Service Letter No. SL-AG-25 May 3, 1963

FUEL SYSTEM

APPLICABILITY: All S-2B, S-2C. 600 S-2C Aircraft, Serial Number thru 1162-C

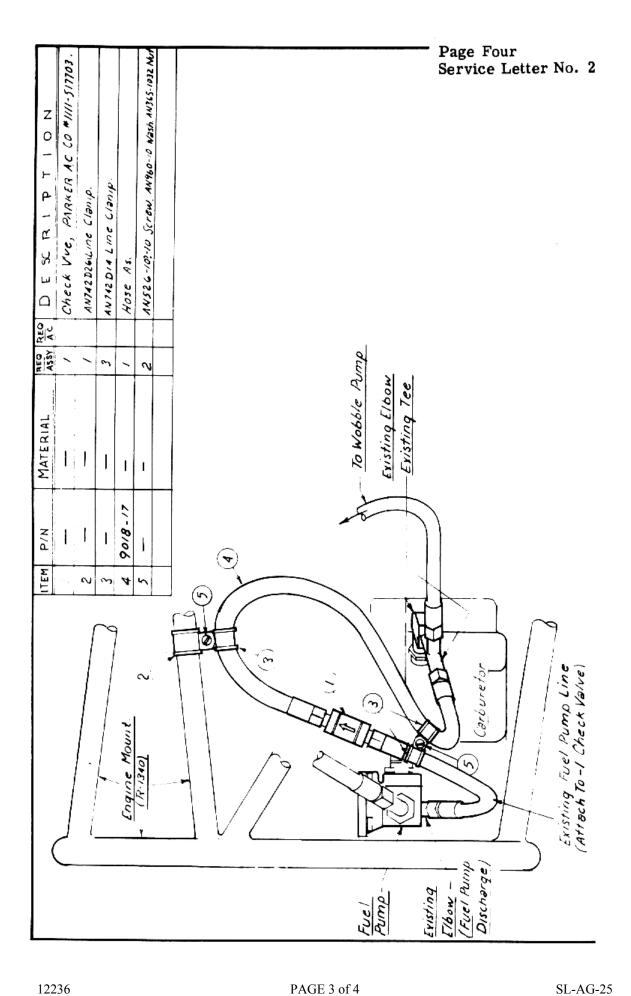
A recent engine stoppage in a 600 S-2C was caused from a small bit of foreign matter collecting under the fuel pump relief valve seat. This resulted in loss of prime of the fuel pump. The wobble pump became ineffective due to air leading from the carburetor bowl through the fuel pump and into the wobble pump vacuum chamber.

In order to guard against this possibility, a check valve should be installed in the discharge line from the fuel pump to the carb.

It is strongly suggested that this check valve be installed immediately. This installation is FAA approved.

Kit containing all necessary parts are available from the factory. Be sure to specify the correct kit number when ordering, since the R-985 kit is slightly different from the R-1340 kit.
